PROJECT
THE MEDICAL CENTER OF AURORA ENDO/ BRONCH RENOVATION
ADDRESS
1501 S. POTOMAC ST.
AURORA, CO 80012

SHEET TITLE
MECHANICAL FLOOR PLANS

SHEET NUMBER
M2.10

RE: Endo-Bronch Room Addendum 1 HVAC Changes

1 FIRST FLOOR PARTIAL PLAN - DEMOLITION - VENTILATION

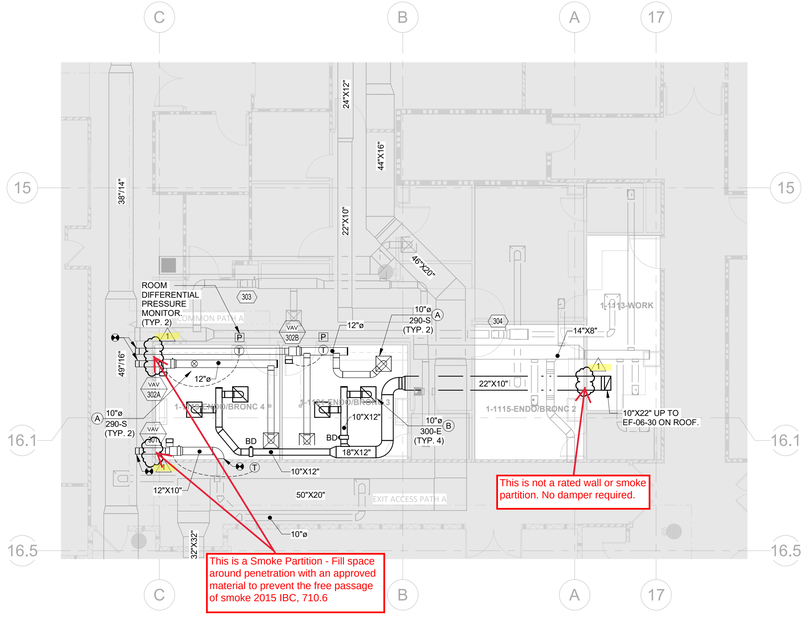
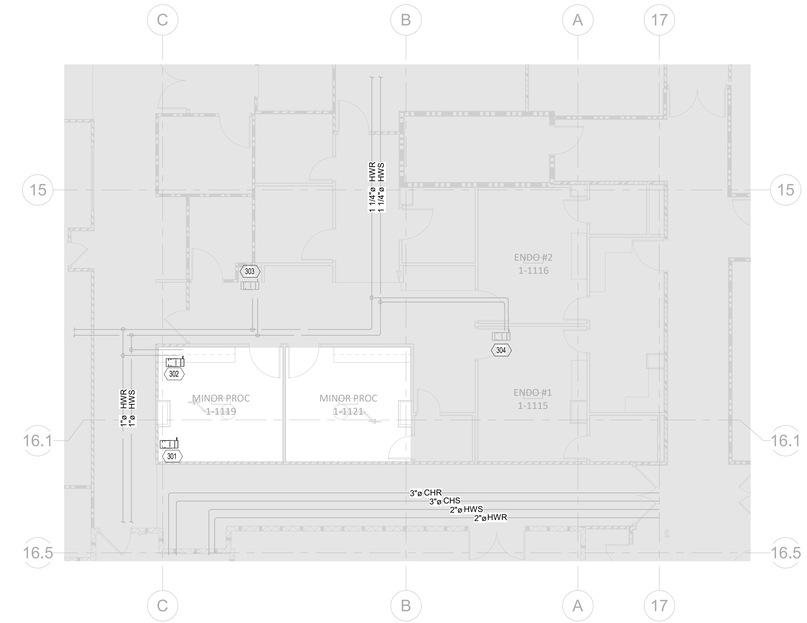
The original scope of work identified for this project included three (3) fire/smoke dampers. Upon further investigation, it was found that these walls are not fire/smoke rated. This addendum includes the removal of the three (3) fire/smoke dampers to meet the actual wall conditions in the endoscopy suite.

1. PATCH ALL DUCT MAINS WHERE BRANCH LINES ARE DEMOLISHED AS SHOWN.
2. ADJUST VAV MAXIMUM DAMPER POSITION TO MEET REQUIRED 0.02" W.G. NEGATIVE PRESSURE WITHIN ENOSCOPY/BRONCHOSCOPY ROOMS.
3. ADD A NOTE "CONTRACTOR SHALL COORDINATE WITH FACILITY ENGINEER TO INCREASE THE AIR HANDLER MINIMUM OUTSIDE AIR SETPOINT BY 1,000 CFM UPON COMPLETION OF THE PROJECT.
